DWG M-3.2 PART PLAN - SEPARATE SYSTEM IN LIEU OF AHU-1

<p>208-897 CORYDON AVE. WINNIPEG, MB. TEL: (204) 925-1150 FAX: (204) 925-1155</p>	<p>PROJECT TITLE: BRONX PARK COMMUNITY CENTRE WINNIPEG, MANITOBA</p>	<p>FILE: 6150-MS-05</p>
	<p>DRAWING TITLE: SEPARATE PRICE ITEM 11 M-3.2 PART PLAN-SEPARATE SYSTEM</p>	<p>DATE: FEB. 14, 2008</p>
		<p>DRAWING NO. / REVISION NO. MS-05</p>

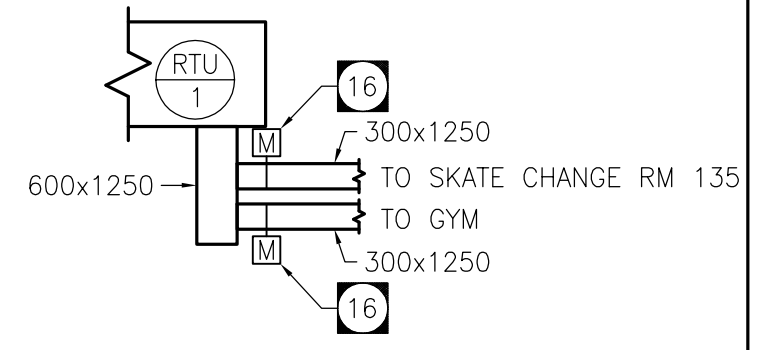
- 19 SEPARATE GYM HEATING/COOLING SYSTEM RTU-1 ON THE ROOF. SEPARATE GYM HEATING /COOLING SYSTEM IS IN LIEU OF AHU-1. REVISE GAS PIPING AS REQUIRED TO SUITE SEPARATE RTU-1.
- 20 ACOUSTICALLY LINED RETURN AIR DUCT (SERVING SEPARATE RTU-1) INSTALLED TIGHT TO THE UNDERSIDE OF THE ROOF DECK BETWEEN THE ROOF JOISTS. COORDINATE INSTALLATION WITH ALL OTHER TRADES.
- 21 TWO ACOUSTICALLY LINED SUPPLY AIR DUCTS (SERVING SEPARATE RTU-1) INSTALLED TIGHT TO THE UNDERSIDE OF THE ROOF DECK BETWEEN THE ROOF JOISTS. COORDINATE INSTALLATION WITH ALL
